**ATTACHMENT 18 – Mn/DOT MEMORANDUMS DOCUMENTING CRACKS IN
THE NORTH APPROACH SPAN GIRDER NEAR PIER 9 FROM OCTOBER 1998
THROUGH NOVEMBER 2000**

Subject: Bridge No. 9340
Cracks in North Approach Span Girder Near Pier 9

Subject: BR 9340 - Cracks in Approach Span Girders, North End of Bridge Near Pier 9

Re: Bridge No. 9340 - Load Test Results

Figure 1
Girder 2 - Prior to Diaphragm Lowering

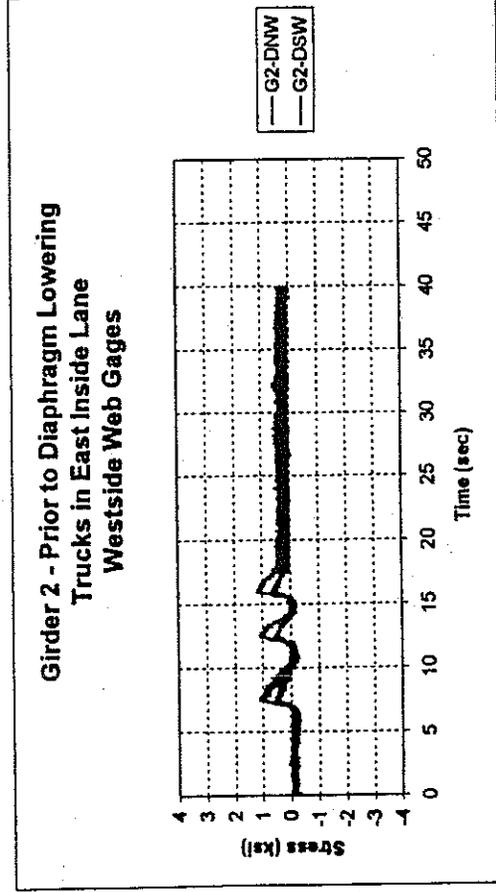
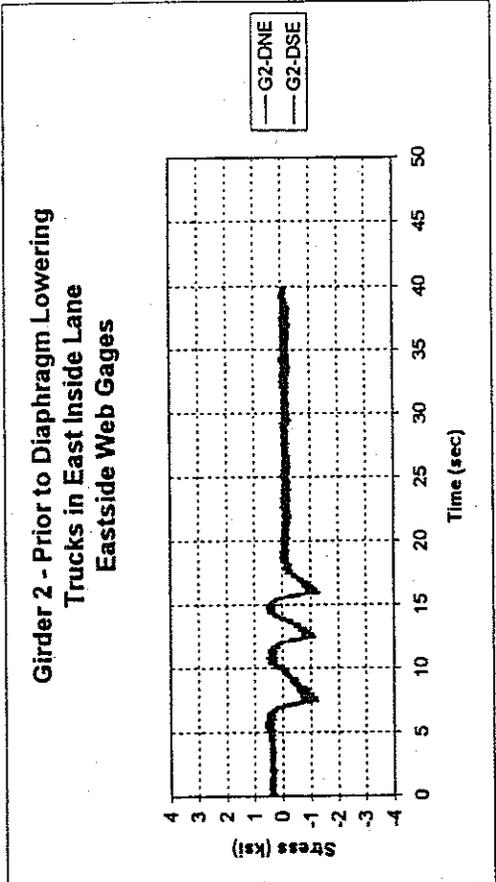
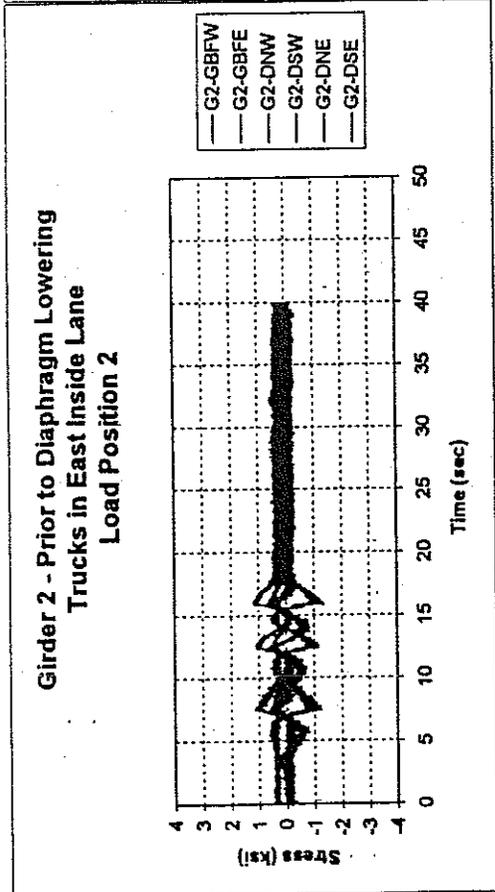
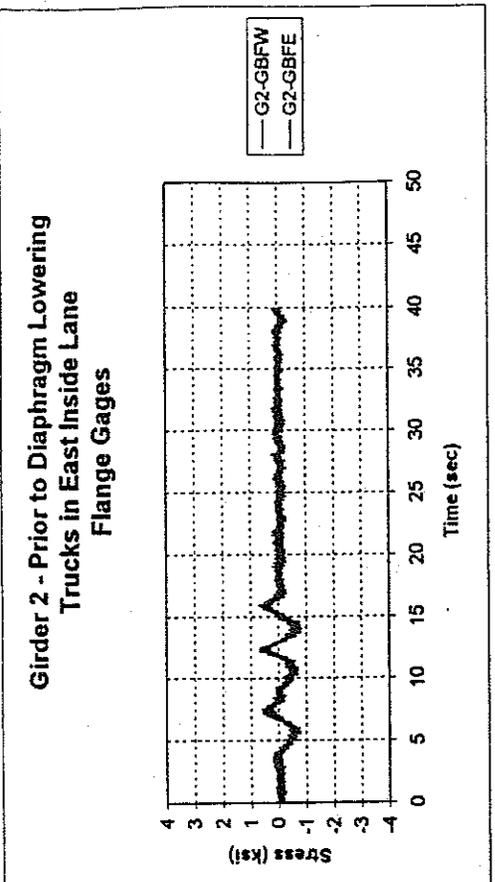
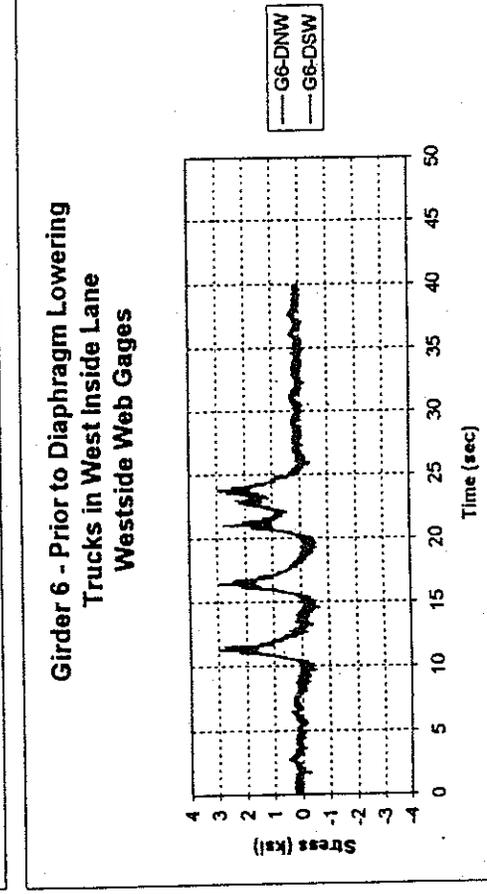
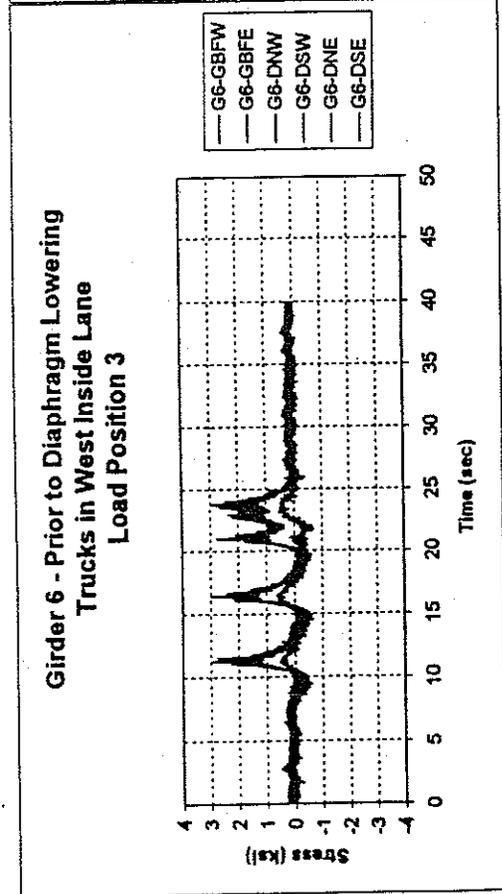
No data from Load Position 1, Load Position 3, and Load Position 4 are shown for Girder 2, because the maximum stresses developed in the web of Girder 2 as a result of the load tests occurred during Load Position 2 (trucks in east inside lane). Figure 1 contains four charts which show stress (ksi) versus time (seconds) in the girder web and compression flange prior to

lowering the diaphragms for Load Position 2. The upper left chart is a comparison of all six strain gages. The upper right chart contains the flange strain data, the lower left chart contains web strain data for the web on the west side, and the lower right chart contains web strain data on the east side of the web. In a like manner, Figure 2 contains the results for Load Position 2 after the diaphragms were released and lowered. Stress values were calculated from the strain gage data collected during the load tests.

Prior to releasing and lowering the diaphragms, the web of Girder 2 near the diaphragm connection plate is bending around the flange, as one would expect. The west side of the web is in tension with a peak value about 1 ksi and the east side of the web is in compression with a peak value about 1 ksi. After the diaphragms were lowered, the stress in the web was almost completely eliminated, with a peak value less than 0.2 ksi. The flange stress and response in both load tests are almost the same, indicating that lowering the diaphragms has not changed the distribution of load among girders or the torsion.

Figure 4
Girder 6 - After Diaphragm Lowering

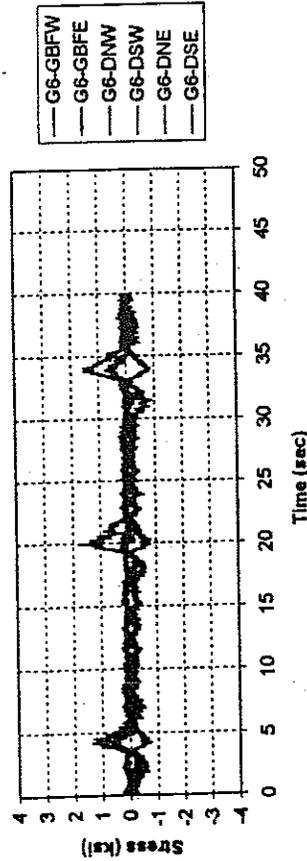
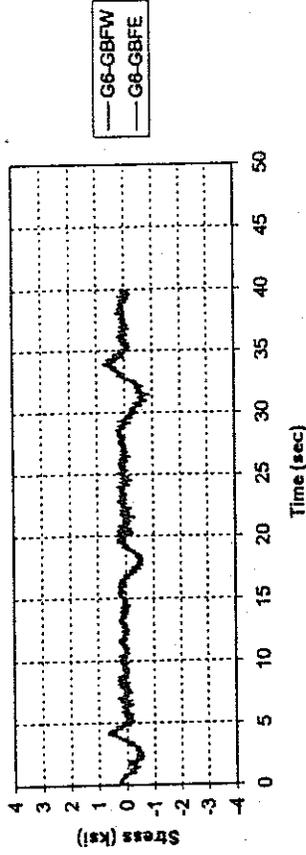
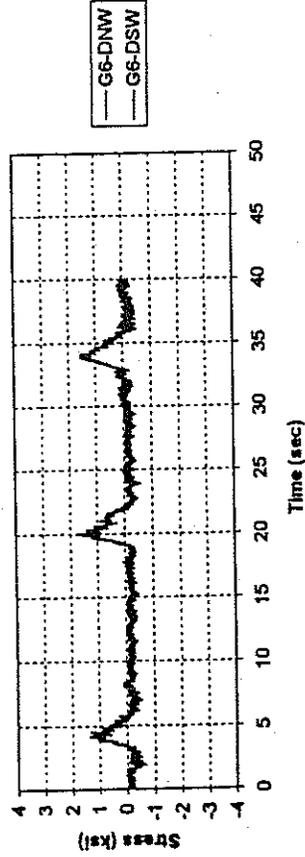
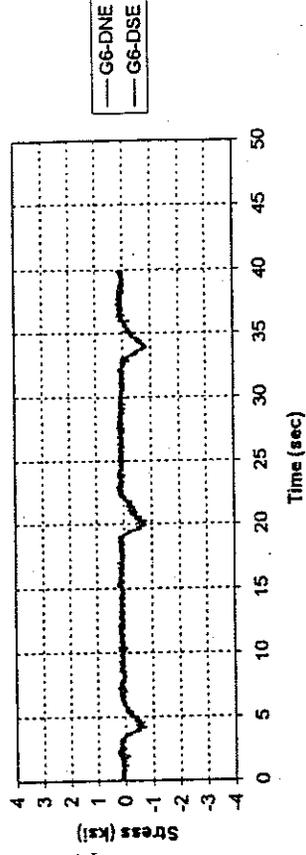
The maximum stresses developed in the web of Girder 6 during the load tests occurred while the trucks were in Load Position 3 (trucks in the west inside lane). As a result, no data from Load Position 1, Load Position 2, and Load Position 4 are shown for Girder 6. Using the same chart layout as explained above, Figure 3 contains the results prior to lowering the diaphragms for Load Position 3 and Figure 4 contains the results for Load Position 3 after the diaphragms were released and lowered.

This section did not behave as expected. Prior to lowering the diaphragms the west side of the web shows a tensile stress of approximately 3 ksi the east side of the web shows a tensile stress of about 2 ksi. One can conclude that the web has a net tensile stress of about 2.5 ksi along with a bending stress of approximately 0.5 ksi. After the diaphragms were released and lowered, the stress on the west side was tensile with a magnitude of approximately 1.2 ksi and on the east side the stress was compressive with a magnitude of about 0.6 ksi. Again this section has a net tensile stress along with a bending component, although the magnitudes are reduced substantially. Similar to Girder 2, the flange stress and response in both load tests are almost the same, indicating that lowering the diaphragms has not changed the distribution of load among girders or the torsion.

The decrease in stress in the affected areas, a factor of over two for Girder 6 and considerably more for Girder 2, should be sufficient to preclude any further cracking in the web. Therefore, on Bridge No. 9340, the University of Minnesota recommends repositioning the diaphragms and decreasing the rigidity of the diaphragm-stiffener connection at other affected locations on the bridge.

INSTRUMENTATION OF GIRDER WEB		BRIDGE #
REV.	DATE	9340
BY	CHK.	APPROVED
SHEET NO. 1 OF 2 SHEETS

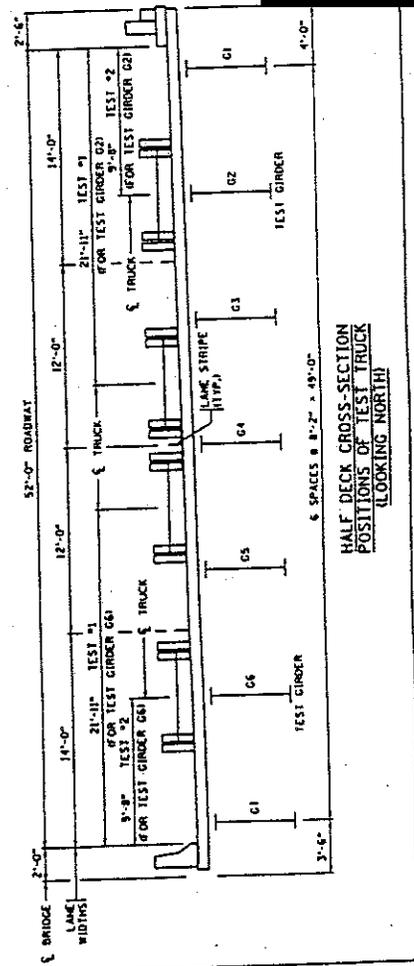
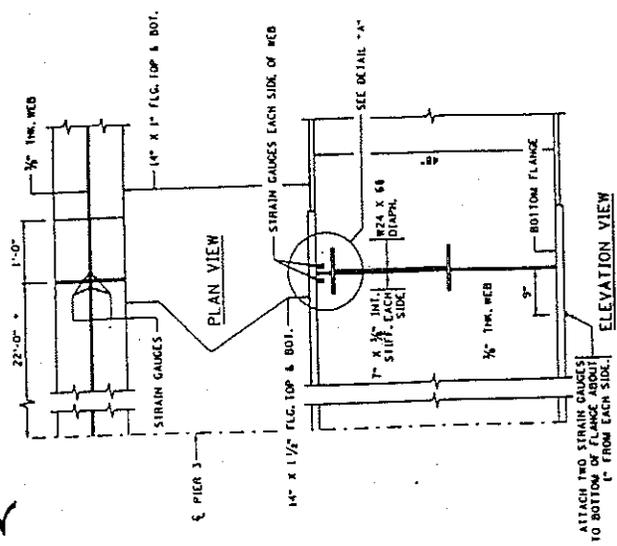
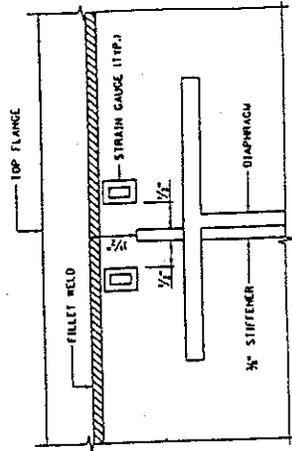
NOTE
FOR TESTING OF GIRDERS, FOLLOW
PROCEDURE GIVEN ON SHEET 2.

ATTACH TWO STRAIN GAUGES TO BOTTOM OF FLANGE ABOUT 1" FROM EACH SIDE.

ATTACH STRAIN GAUGES TO WEB AND BOTTOM FLANGE IN POSITIONS SHOWN. STRAIN GAUGES ON WEB SHOULD BE AS CLOSE AS POSSIBLE TO THE TOP OF THE FILLET WELD. DO NOT PLACE ON WELD FILLETS.

BRIDGE NO. 9340
SOUTH APPROACH SPANS
STRUCTURAL STEEL DETAILS
APPROX - 6-18-97

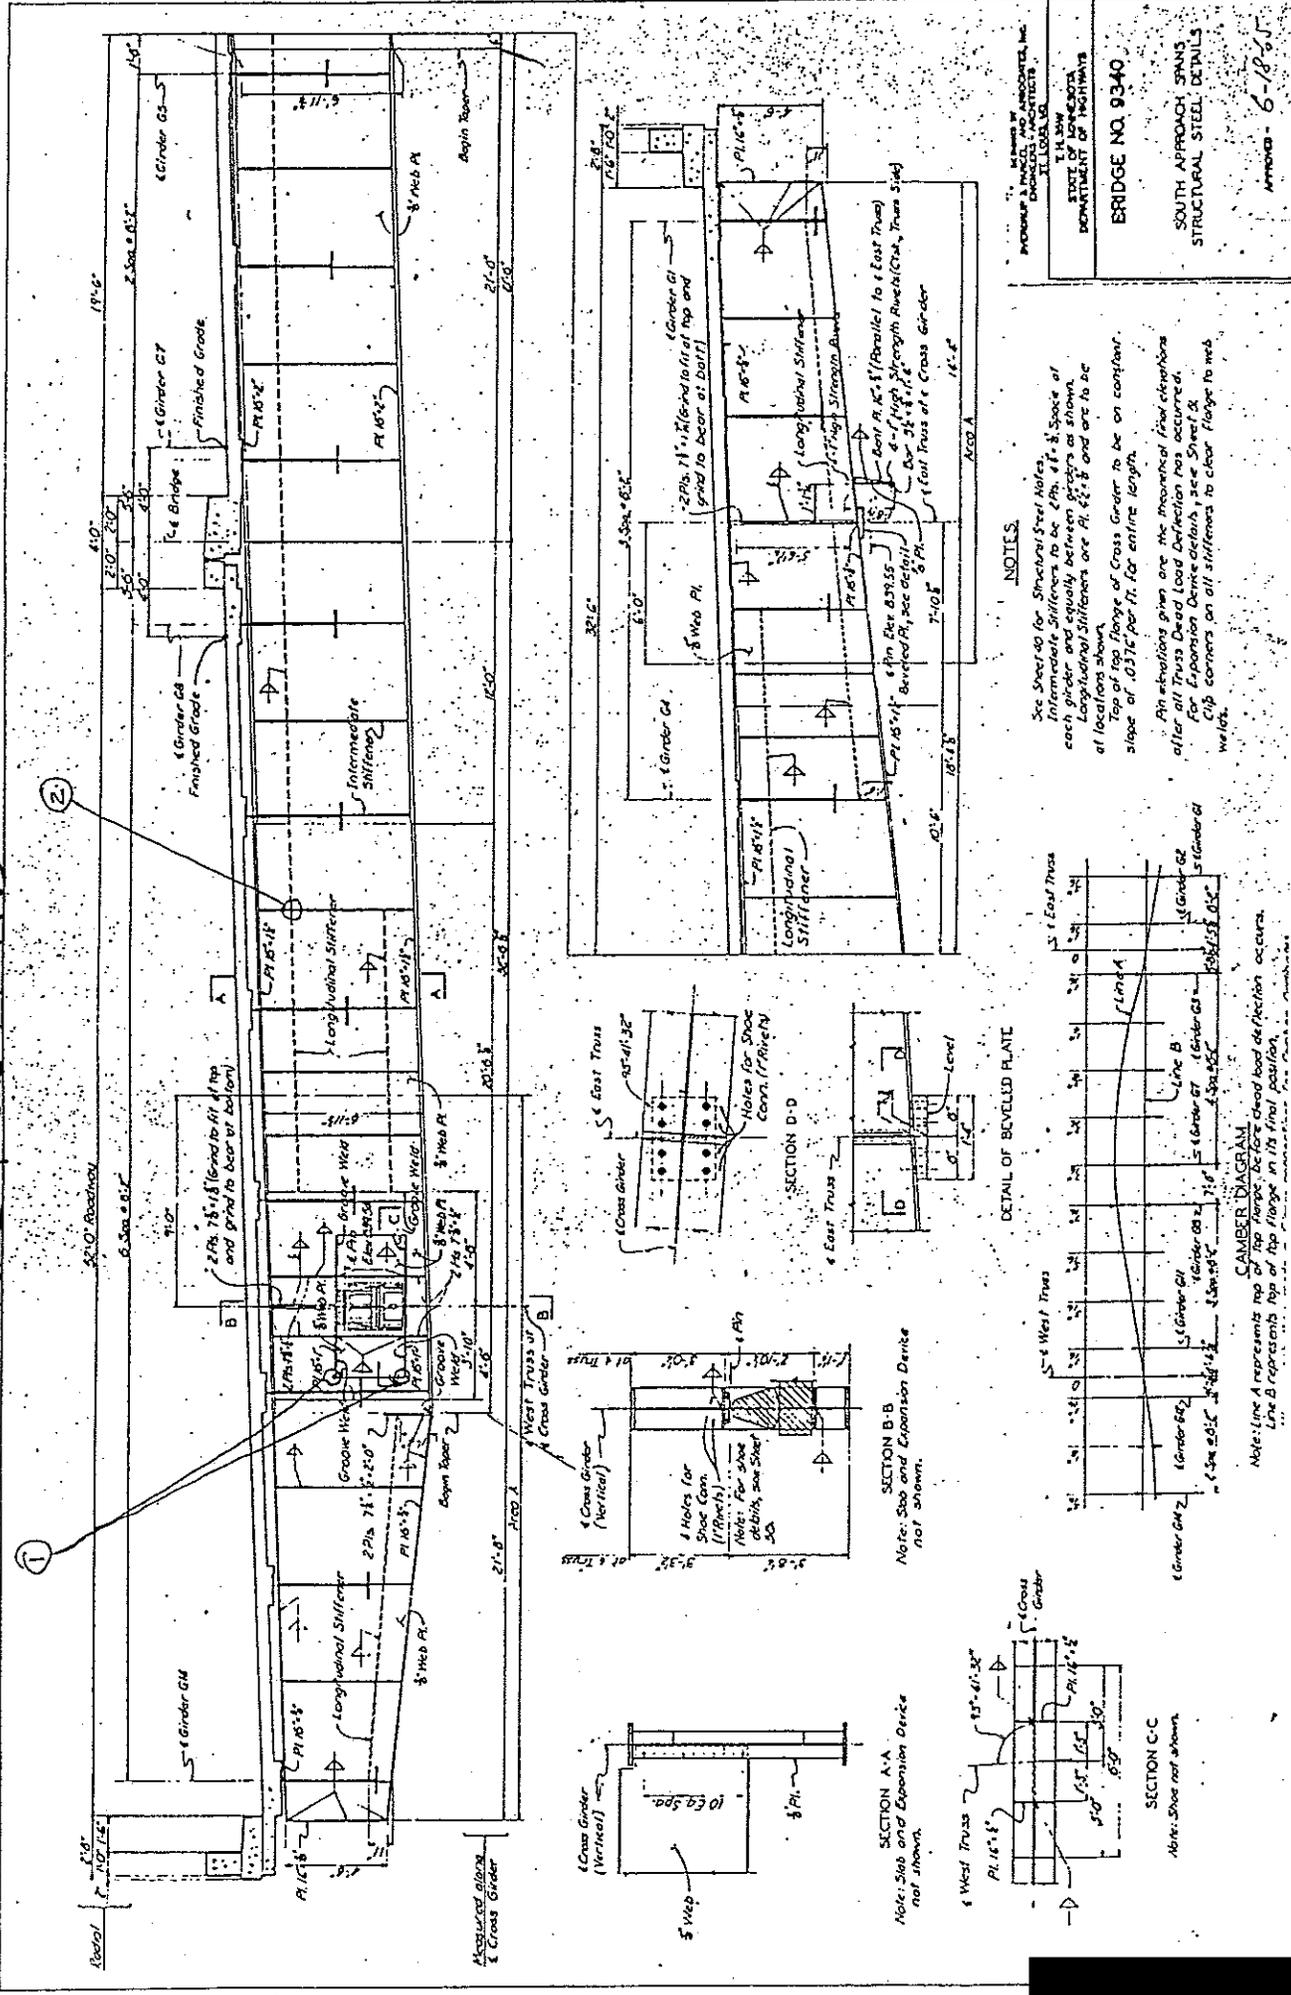
Floor Beam
Cracks Found in 1998
Also Some found in 1997
Some found in 1993

21 Crack Locations
